Re: P.Z. 20-14 Happy Hounds Playground, LLC, c/o Clayton Engineering, Steve Quigley

Re: P.Z. 20-14 Happy Hounds Playground, L.L.C.; a Conditional Use Permit (CUP) in the NU Non-Urban Residence District for a recreational land use facility (commercial dog park) at 2440 and 2448 Pond Road (Locator Numbers 23W34042 and 23W330032).

The Department of Planning, in conjunction with the Department of Public Works, has completed its third review of the Site Development Plan being submitted in association with the approved Conditional Use Permit (CUP) in the NU Non-Urban Residence District for a recreational land use facility (commercial dog park) at the above-referenced location. This review centered on the plan's compliance with the applicable sections of the City's Zoning Ordinance, the Conditional Use Permit (CUP) for the tract of land, and other related requirements and design criteria of the City of Wildwood. In this comparison, a number of items were identified that must be addressed, before this matter can be scheduled for Site Plan Subcommittee's review. These items are as follows:

Re: Landscape Plan Review #1
Happy Hounds Playground
2448 Pond Road
terraspec Job Number 02038-98

STORMWATER POLLUTION PREVENTION PLAN (SWPPP)

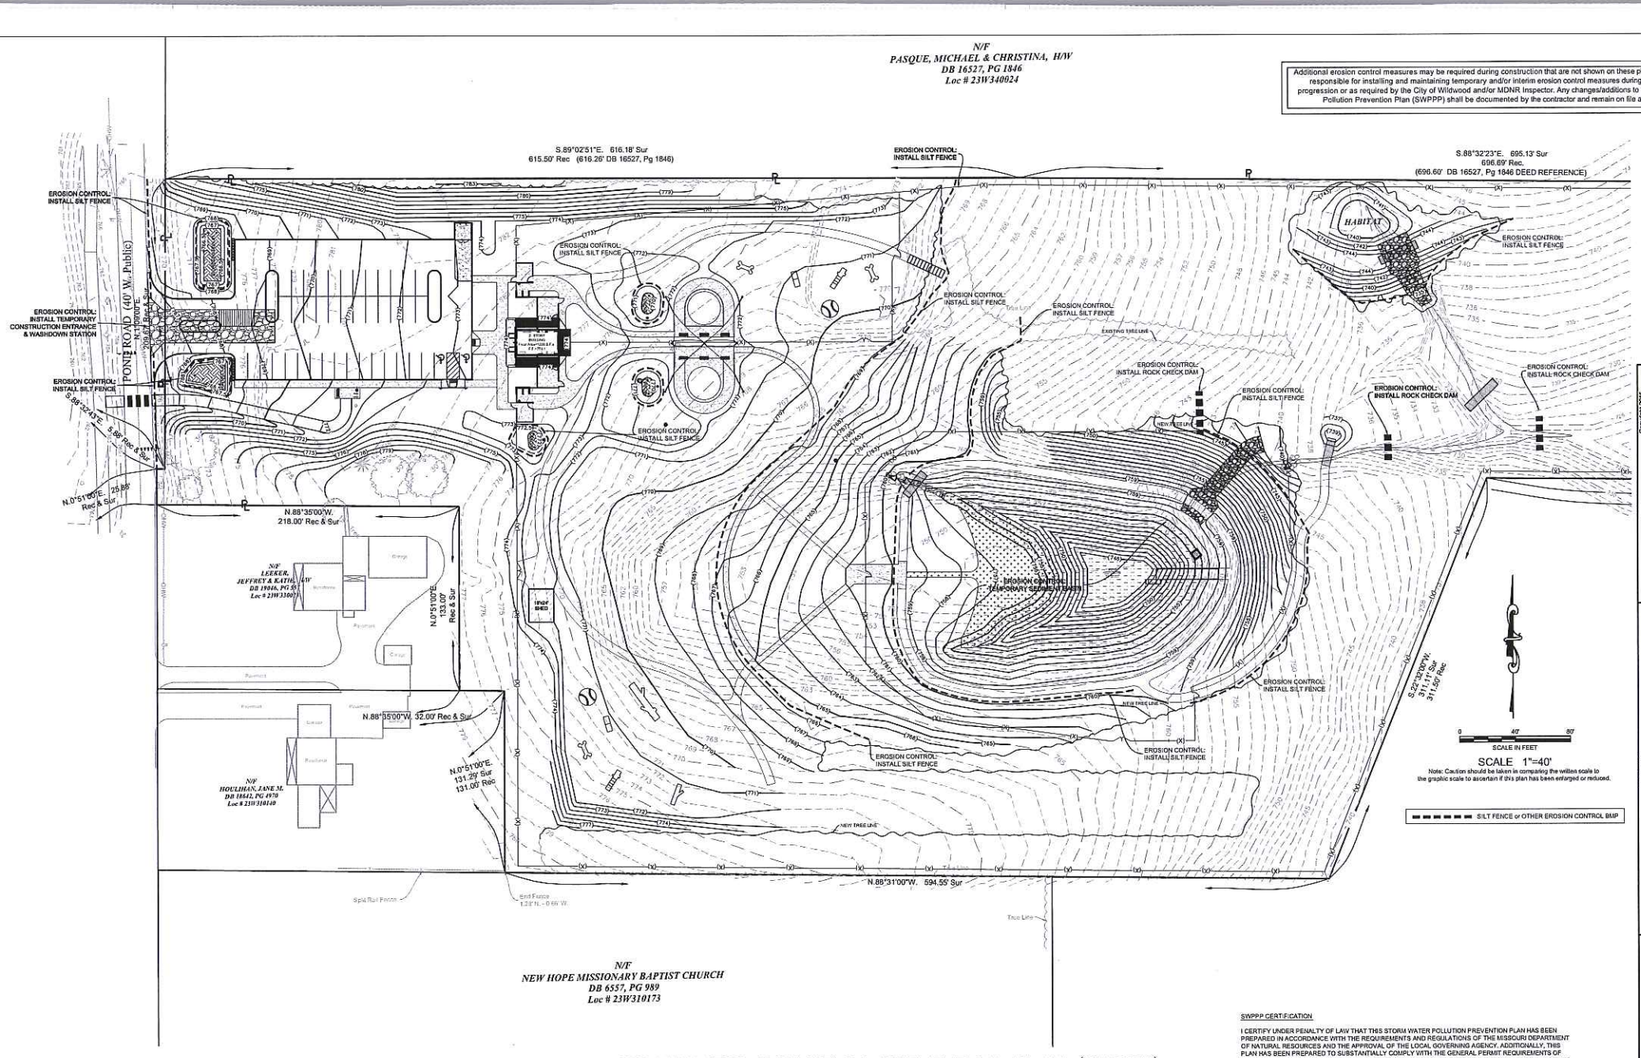
8. Please add the owners' script to the SWPPP, in addition to the engineer's signature block.
